## PRODUCT TECHNICAL BULLETIN 36307 GRADER PARK BRAKE PINION SHAFT – DESIGN IMPROVEMENT

REVISION:A

**Date:** Jan 2024  
**Issue:** A (release)  
**Prepared for:** Industry/ End Users

**Applicable machines:** Graders installed with mechanical park brake legacy pinion shaft 7-090909-700  
(serial numbers 014 – 039)

**Figure 1: Original Park brake assembly 7-090942-700 indicating spline adaptor shaft (no longer required)**

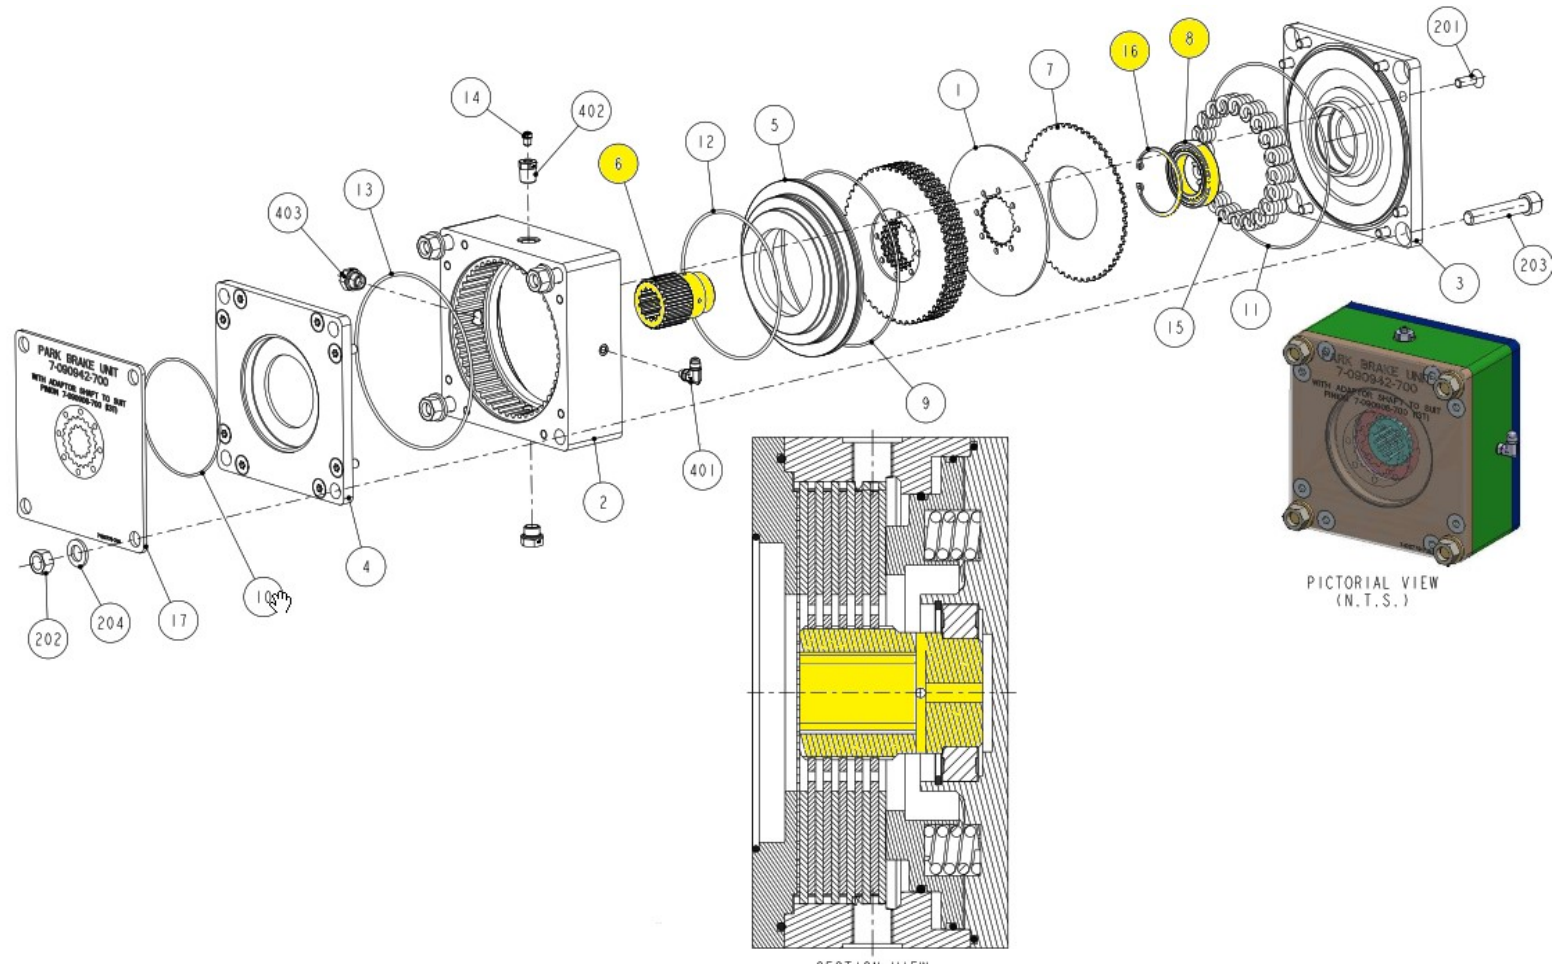
The Pinion adaptor shaft in park brake assembly 7-090942-700 is no longer required as the pinion shaft direct engages the brake discs – refer figure 1

NOTE: when installed with the new pinion shaft, this adaptor is not required, if ordering a new brake assembly to suit the upgraded pinion, it can be ordered as **7-090942-700U** to be supplied without the spline adaptor shaft.

**Figure 2: The above indicated components are replaced for the pinion upgrade**

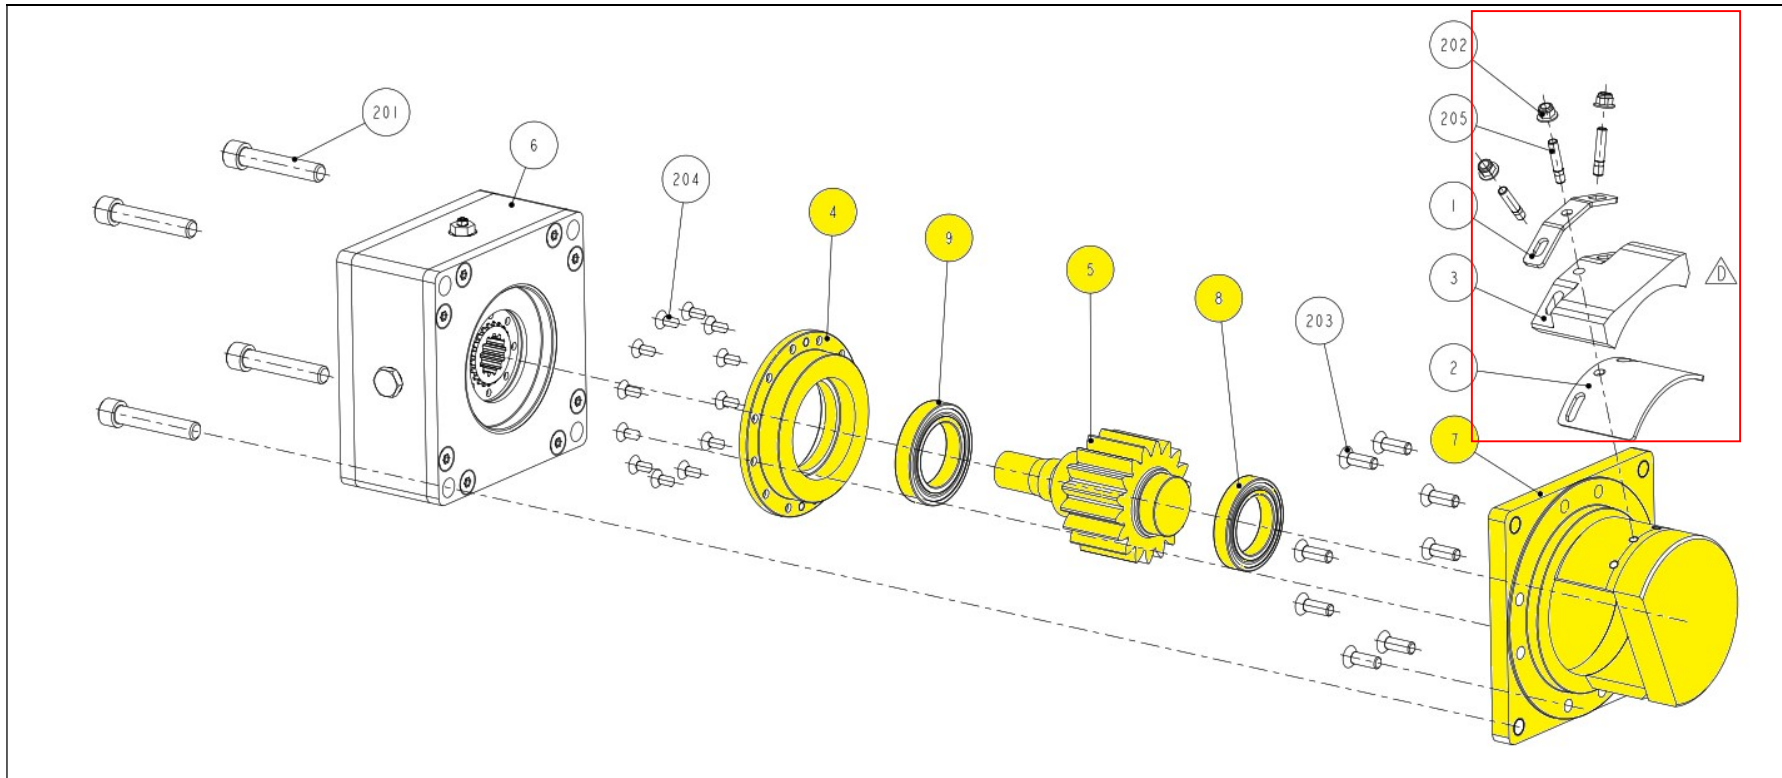
NOTE: The upgraded Pinion shaft design also includes an improved chain guide as indicated by items the red box. The chain guide has additional fasteners to prevent slippage of the chain guide.
